COMMISSION DIRECTIVE

adapting to technical progress Council Directive 77/541/EEC on the approximation of the laws of the Member States relating to safety belts and restraint systems of motor vehicles

(90/628/EEC)

Figure 1 TROLLEY, SEAT, ANCHORAGE

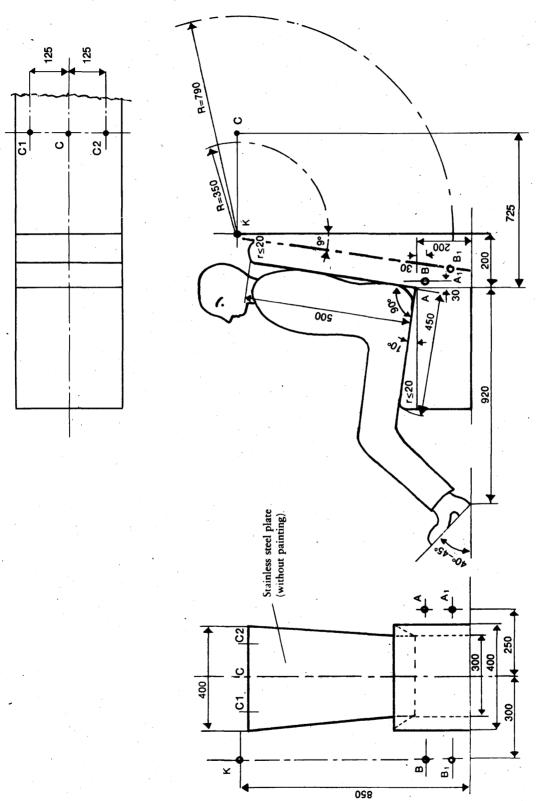
'The tolerance on the position of the anchorage points is such that each anchorage point shall be situated at most at 50 mm from corresponding A, B and K indicated in figure 1, or A1, B1 and K, as the case may be.'

'3.1. In the case of a belt equipped with a belt adjustment device for height as defined in 1.8.6 of this Directive, this device shall be secured either to a rigid frame, or to a part of the vehicle on which it is normally mounted which shall be securely fixed on the test trolley.'

Figure 1 is replaced by the following figure:
